TECHNICAL
BASIS for
REGULATION

TBR 14
pr **A1**

**This draft amendment A1, if approved, will modify
the Technical Basis for Regulation TBR 14 (1994)**

**Business TeleCommunications (BTC);
64 kbit/s digital unrestricted leased line
with octet integrity (D64U)**

Figure 1

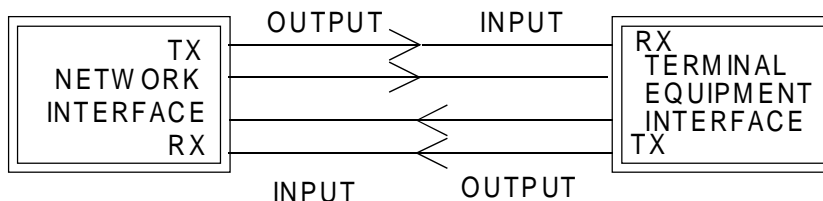
The transmit pair is the output from the terminal equipment interface. The receive pair is the input to the terminal equipment interface, as shown in figure 1. Where the terms "output" and "input" are used without qualification in this TBR, they refer to the terminal equipment interface.
